## AGENDA

Village of Chenequa Plan Commission  
Monday, June 8, 2026, at 6:00 p.m.  
31275 W. County Road K, Chenequa, WI 53029

## STAFF REVIEW

Re: Stormwater Management Plan (SWMP) Review of 31745 West Muscovy Road Drainage Improvements  
Village of Chenequa, Wisconsin (Village)

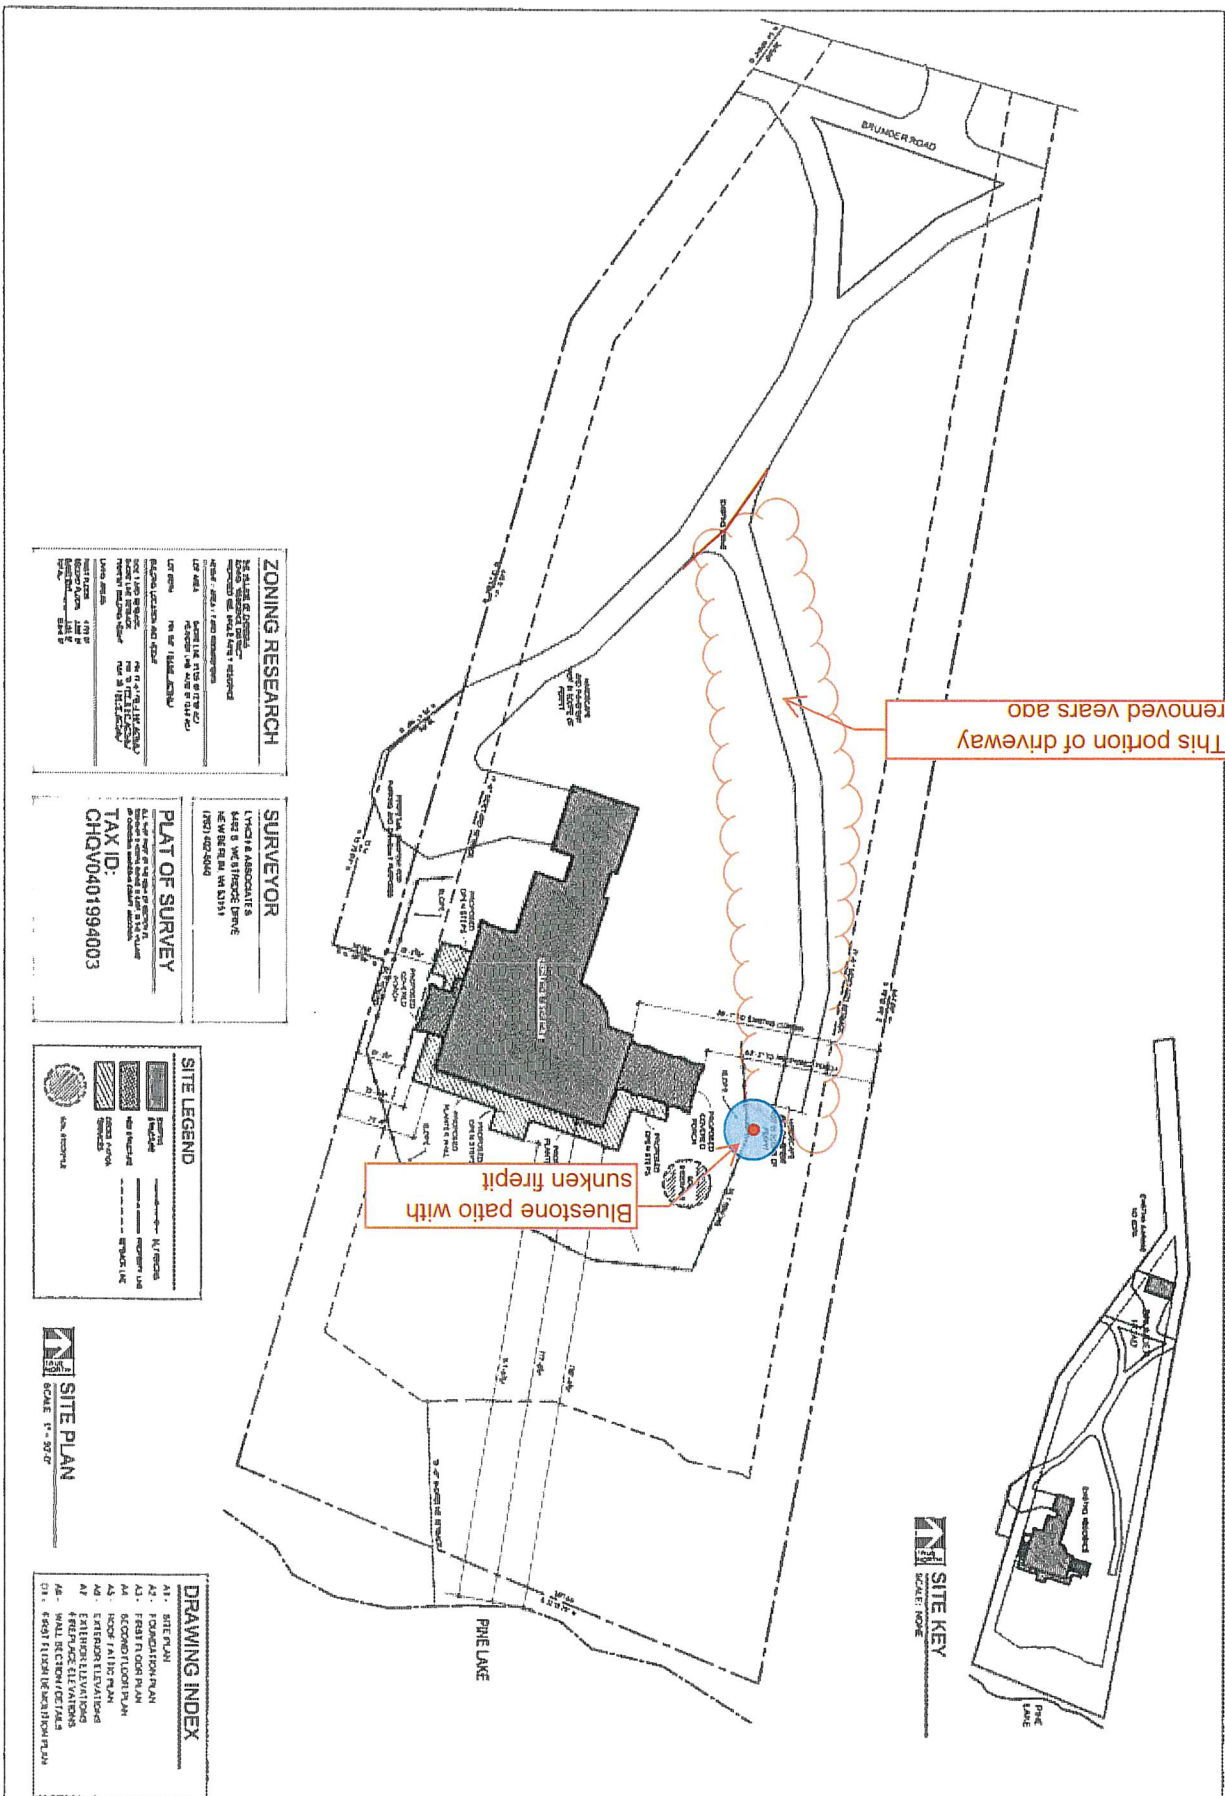
The Village received a complaint regarding grading and patio installation activities completed at 6208 N. Brumder Road. Upon review, it was determined that the work was completed without the permits and approvals required under the Village Code.

The violations include:

1. Grading activities conducted without a grading permit, contrary to Section 5.4(1)(c), which requires a grading permit for grade changes of twelve (12) inches or greater or for land disturbing activities likely to cause erosion.
2. Construction of a patio without a building permit, contrary to Section 5.4(1)(a). Under Section 5.2(2), a patio qualifies as a structure and therefore requires permitting prior to construction.

The patio consists of a bluestone pavers with an at-grade firepit in the center. In total, the patio is approximately 20' feet in diameter. **\*Including the patio total impervious surface of the lot is approximately 21%.**

While the work was completed without the required approvals, the project does meet the applicable requirements of Chapter 5 (Building Code) and Chapter 6 (Zoning Code). As a result, the matter is being brought forward for after-the-fact permitting, Plan Commission review, and Village Board consideration in accordance with Village procedures.

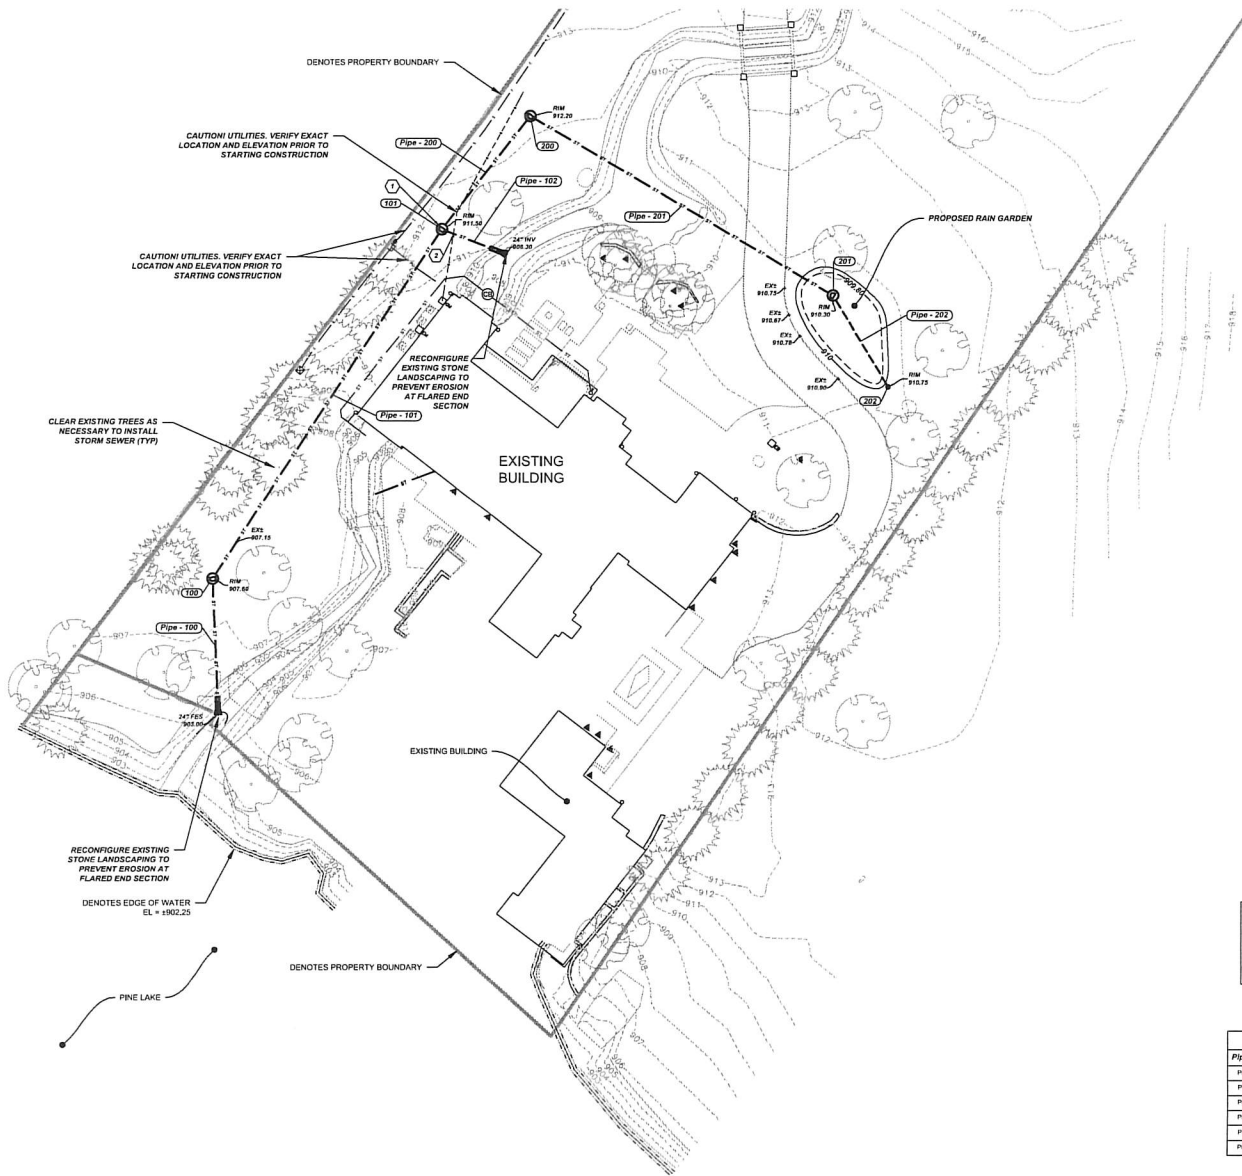
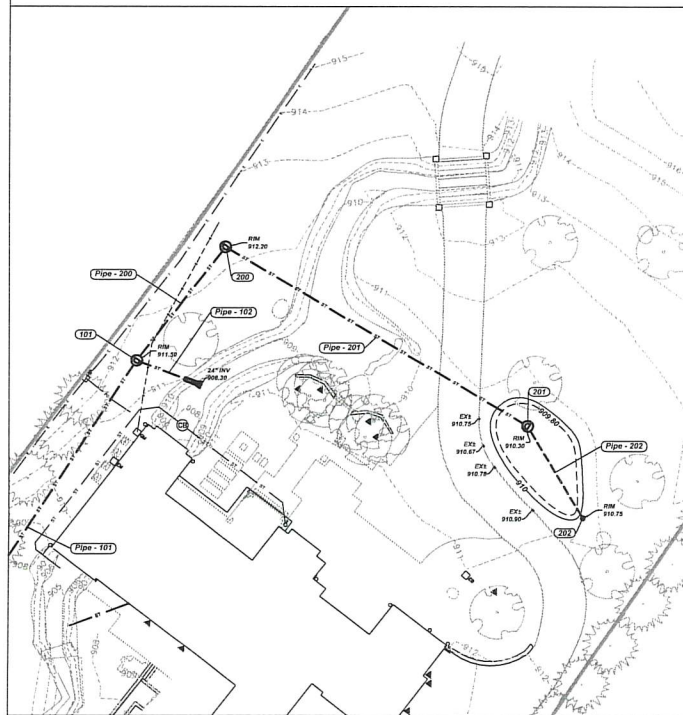
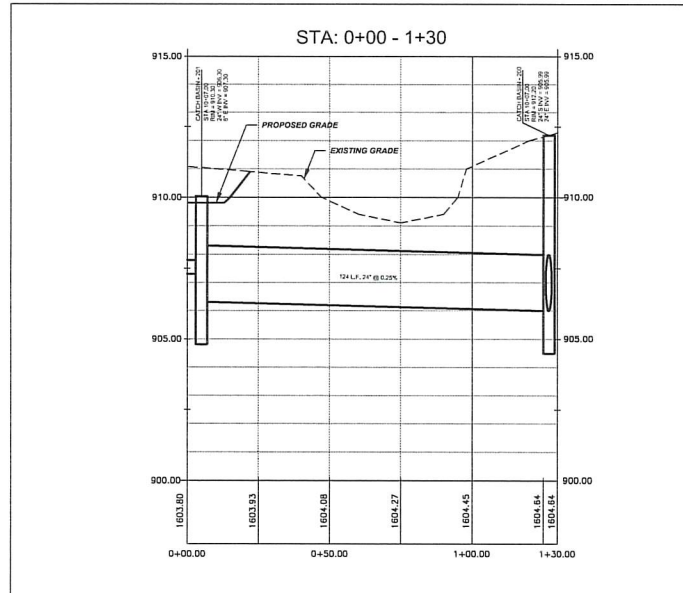
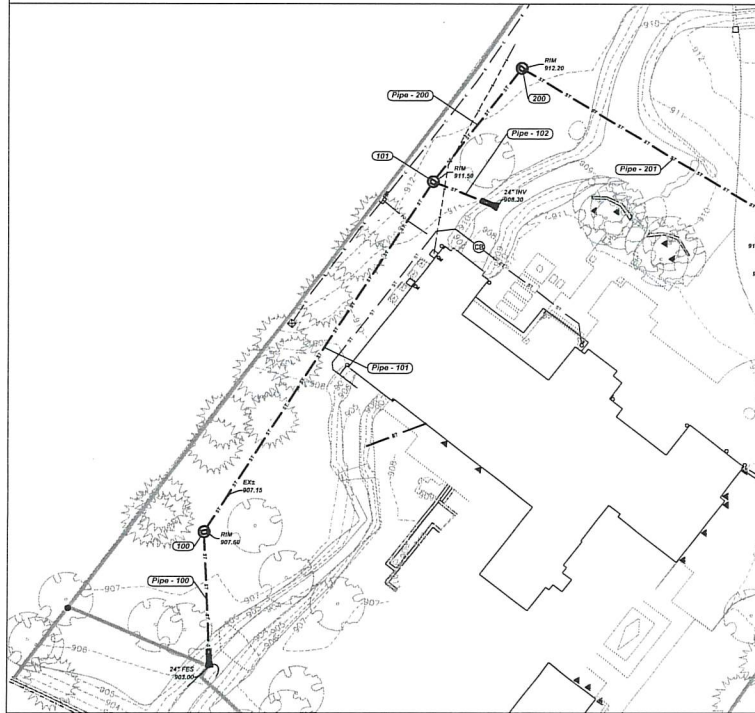
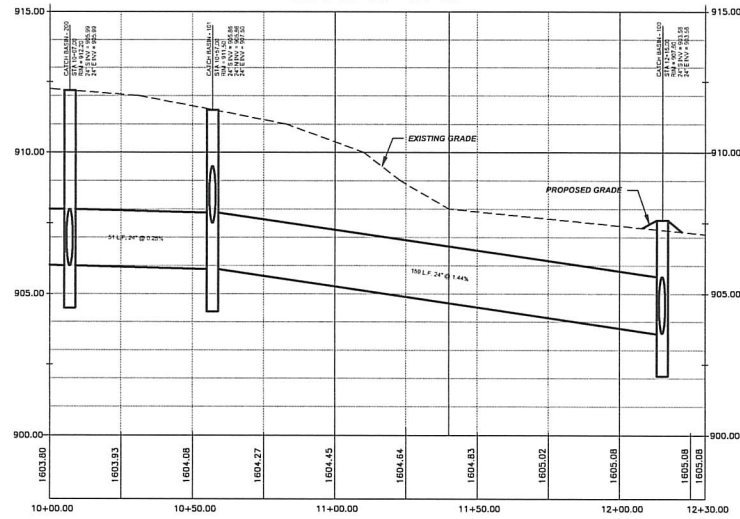
The Joerres property contains an existing dry riverbed drainage feature that currently terminates at the foundation of the primary dwelling. Stormwater is then carried around the foundation through an existing 12-inch pipe, which daylights back into the dry riverbed on the lakeside of the residence. In recent years, this configuration has reportedly resulted in significant stormwater backup and localized flooding issues during major rain events.

To address these concerns, Harwood Engineering has prepared a stormwater improvement plan intended to better manage runoff and reduce the likelihood of future flooding. The proposal includes the following components:

1. Installation of a raingarden closer to the source of runoff in order to capture and infiltrate stormwater before it reaches the existing drainage system.
2. Conveyance of overflow stormwater underground via a proposed 24-inch pipe directed toward the existing dry creek bed system.
3. Replacement of the existing 12-inch foundation bypass pipe with a new 24-inch pipe intended to improve stormwater capacity and reduce the potential for backups and flooding around the residence.

Like the existing system, the proposed pipe will continue to discharge on the lakeside of the primary dwelling into the existing drainage feature. No additional grading, shoreline alteration, or site modifications are proposed at this time. Because of the increased pipe diameter, the location in which the pipe daylights is closer to the lake than where the existing pipe terminates.

The proposed plans were reviewed by Isak Fruchtman of Strand Associates, who concluded that the project does not trigger applicable state or local stormwater management regulations. Based upon that review, the proposed work is considered a maintenance and stormwater mitigation effort intended to improve the functionality of an existing drainage system rather than create additional stormwater impacts. The project does not involve the creation of new impervious surfaces, substantial land disturbance, or modifications that would otherwise trigger formal stormwater permitting under current State or Village regulations.

The proposed redevelopment involves less than 1 acre of overall site disturbance, no increase in exposed parking lot or roadway, and is generally limited to underground utility construction. Therefore, it is exempt from meeting any of the construction site or postconstruction performance standards identified in NR 151.

Land disturbing activities appear to exceed an area of 5,000 square feet. Therefore, an erosion control plan should be submitted in accordance with the standards identified in the Ordinances. Village staff or representatives should review erosion control plan materials upon receipt.

PROJECT	FINE COTTAGE, USA		
TITLE	Materials Plan		
SCALE	1"=30'0"@A1	DATE	March 2026
DRAWN	AC	CHECKED	LR
DWG NO.	S340-CP-01A

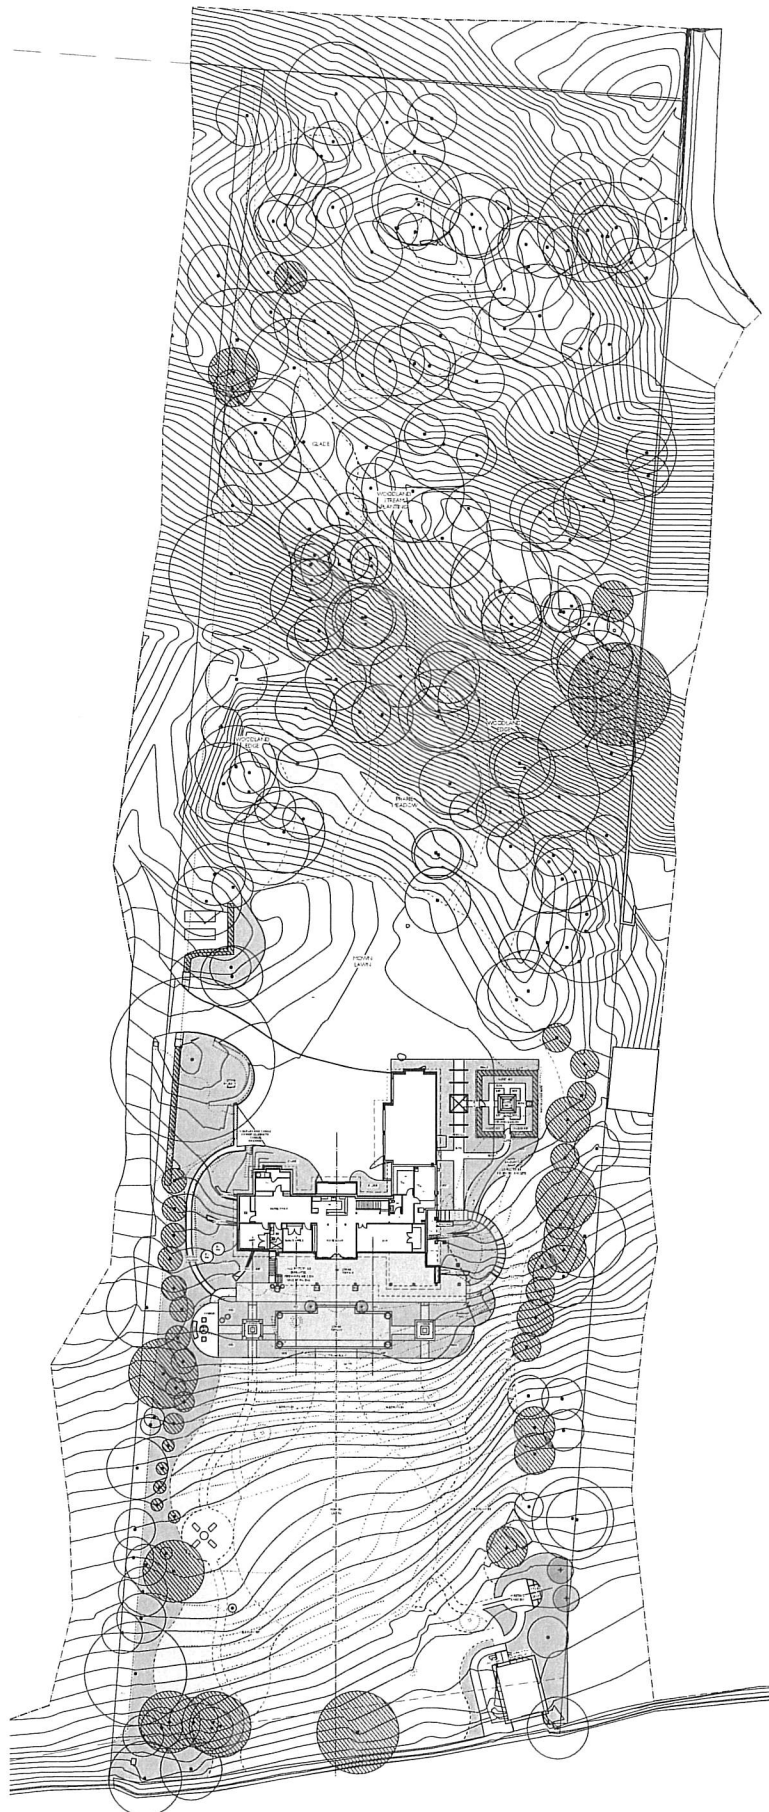
- a. Two stone terraces are proposed to be installed on the lakeside of the primary residence.
- b. Terraces will be constructed of limestone pavers with limestone cobbles as an accent.
- c. Both terraces are well beyond the 75' setback from the OHWM of Pine Lake.
- d. Details and layout are illustrated on provided landscape plan.

- a. South of the aforementioned terraces is a proposed cobble patio area with cobble path connecting to the main driveway.
- b. The path and patio will be constructed of "Valders Limestone Cobbles".
- c. As proposed, there is a firepit and seating area proposed on this patio.

**5340-PL-02 PERGOLA + RUSTIC ARBOR LOCATION PLAN**

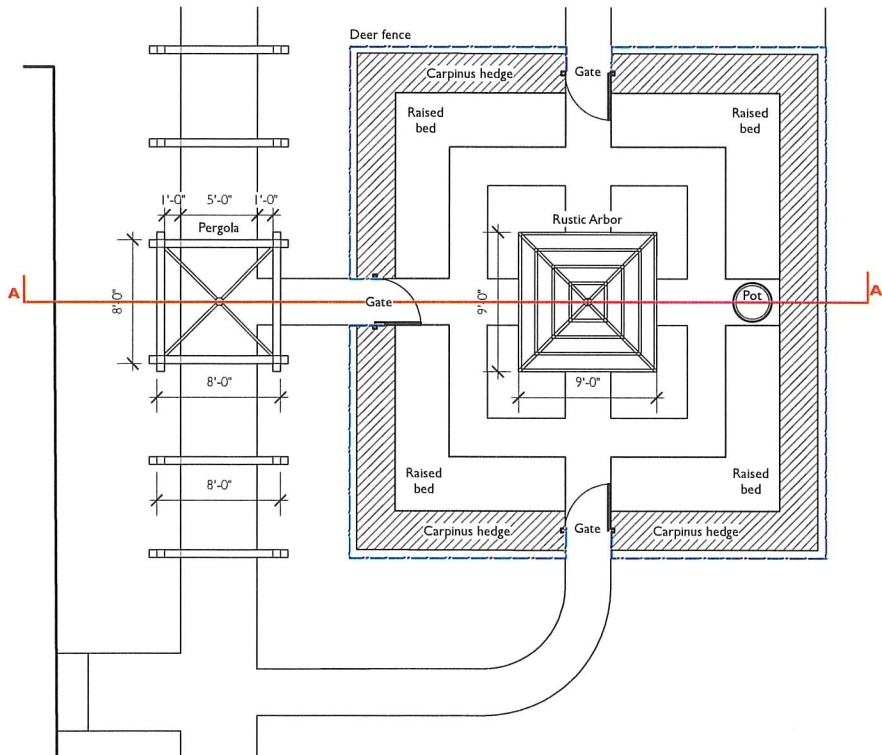
- a. As proposed, there is a kitchen garden to be installed to the North of the primary residence.
- b. The proposed kitchen garden will have raised beds, a path and a "Rustic Arbor".

1. A sample photo of the arbor has been provided on the second page of the document titled "The Pine Cottage- Bespoke Rustic Structures".
  2. "Rustic Arbor" is proposed to be 11' in height.

2. The proposed fence will be 5' in height.
- d. Between the kitchen garden and home is a path with a pergola structure.
  1. A sample photo of the pergola structure has been provided on the second page of the document titled "The Pine Cottage- Bespoke Rustic Structures".

2. The proposed pergola will be 8' in height.
- e. Layout has been illustrated on provided landscape plan.
